NOISE—"BUZZ" COMING FROM CENTER OR RIGHT SIDE OF INSTRUMENT PANEL—HEARD AT IDLE OR LOW SPEED DRIVING	Article No. 01-4-10

FORD: 2001 EXPLORER

Figure 1 - Article 01-4-10

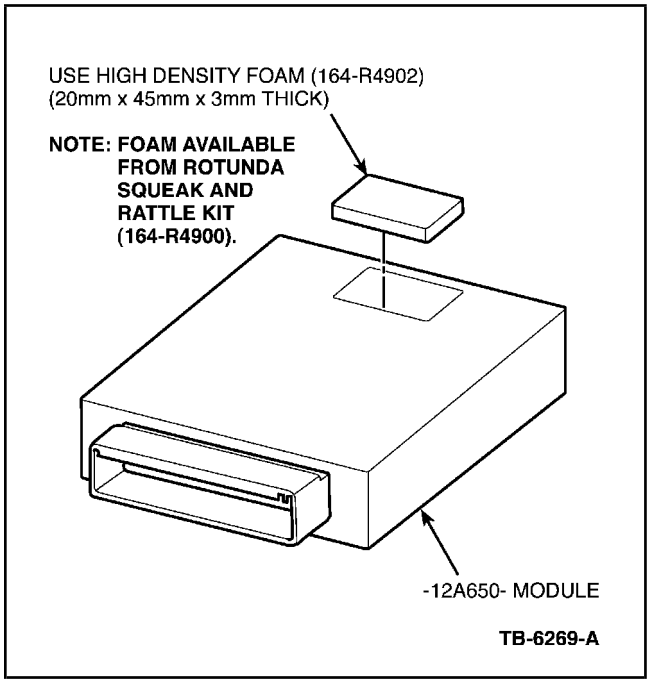
Some Sport and Sport Trac vehicles built between 7/1/2000 and 2/28/2001 may exhibit a "buzz" coming from the center or right side of the instrument panel at idle and/or low speed driving with rpm range between base idle and 1800 rpm. This may be caused by the Powertrain Control Module (PCM) resonating against the heat shield that is located inside the PCM.

1. Remove the PCM from the vehicle. Refer to the 2001 Explorer Workshop Manual, Section 303-14 for removal procedure.
2. Cut a piece of Urethane Tape (hard foam), Rotunda part number 164-R4902, to the following dimensions: 20mm width, 3mm thickness, and 45mm length. The urethane tape is located in the Rotunda Squeak and Rattle Kit, part number 164-R4900.
3. Lay the PCM flat on a table. After removing the adhesive backing, place the foam tape on the top surface of the module at the rear center of the module. This will dampen the buzz noise from the PCM outer case. (Figure 1).
4. Reinstall the PCM. Refer to the Workshop Manual, Section 303-14 for installation procedure.
5. Test drive vehicle to verify that the noise is corrected.
